**RESPONSE TO THE NOVEMBER 24, 2011 INFORMATION REQUESTS FROM THE
MACKENZIE VALLEY ENVIRONMENTAL IMPACT REVIEW BOARD
FOR THE THOR LAKE RARE EARTH ELEMENT PROJECT
DEVELOPER'S ASSESSMENT REPORT**

**Submitted To:
MACKENZIE VALLEY ENVIRONMENTAL IMPACT REVIEW BOARD**

December 2011

Figure 4.8-3

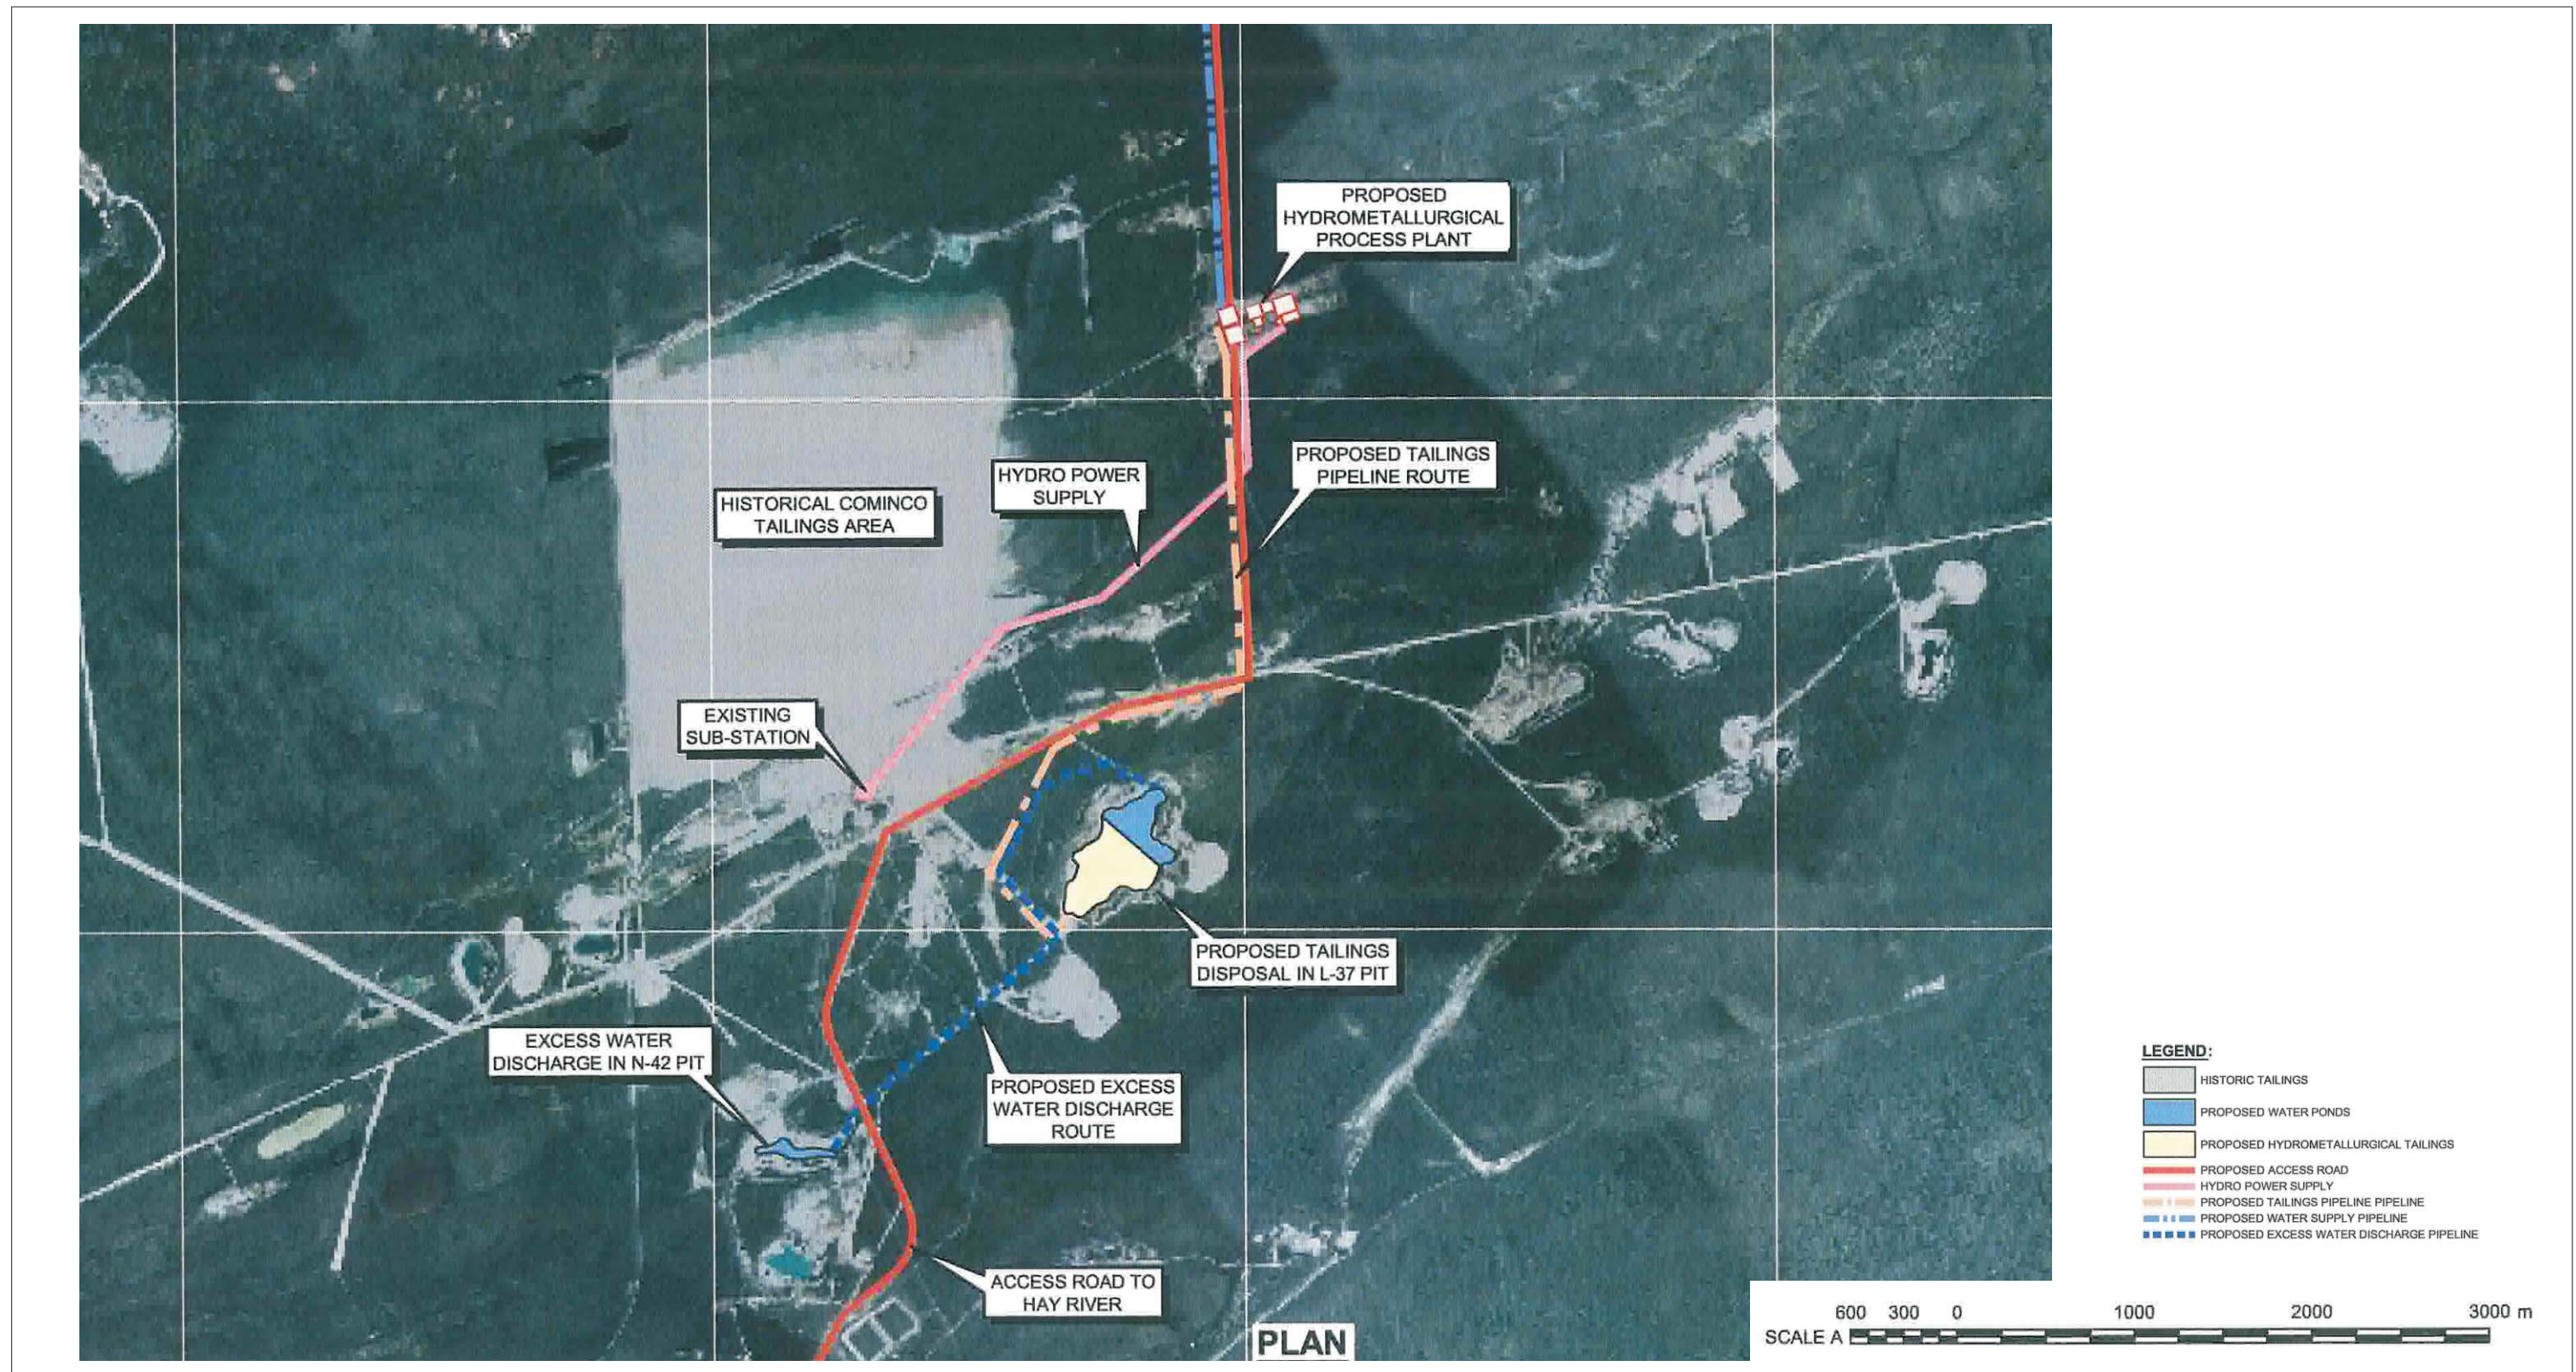
The DAR does not include any discussion of the potential impacts of the tailings delivery pipelines freezing, leaking, or rupturing. Freezing or failure of the flotation plant tailings delivery pipeline could cause uncontrolled slurry loss anywhere along the pipeline route at up to nearly 53 m3 per hour, including several locations uphill from and close to Fred, Cressy, and Thor lakes.

Please describe the engineering safety features and operational controls designed to prevent or minimize the consequences of the tailings delivery pipeline freezing or failing. Please also describe the foreseeable potential impacts of a pipeline failure on the streams, wetlands, or surface water bodies along the routes of both the flotation plant and the hydrometallurgical plant tailings delivery pipelines.

Figure 4.8-3 of the DAR (re-presented with this response) illustrates the general layout of the originally proposed tailings delivery pipeline system extending from the Hydrometallurgical Plant to the Hydrometallurgical Tailings Facility (HTF) to be located in the former L-37 Pit. As illustrated in this figure, the tailings pipeline alignment was located along existing roads and a previously cleared right-of-way. The length of the pipeline between the plant site and the HTF was approximately 4.1 km.

With Avalon's updated plan site (as described in an August 12, 2011 letter from Avalon to the MVEIRB) to relocate the Hydrometallurgical Plant directly adjacent to the existing Hydro-electric substation located in the much larger brownfields area of the former Pine Point Mine, the length of the tailings pipeline to the HTF, which follows an existing road, has been reduced to approximately 1 km. Figure GA -000 – 001 from the Application for Commissioner's Land – Commercial/Industrial Use, illustrates the proposed new location of the Hydrometallurgical Plant site and associated infrastructure.

The existing road from the new plant location to the HTF passes through a Labrador Tea – Subhygric Forest as shown in 2.10-4 of the DAR. Black spruce and jack pine are the common canopy components of this ecosystem type. However, the existing access road area has been extensively disturbed due to historic activities in the area. Thus, the entire pipeline alignment will be located on previously disturbed terrain.

As a result, any spilled tailings caused by a potential HTF tailings delivery pipeline failure would be expected to be deposited alongside the existing access road within the area of historically disturbed terrain.
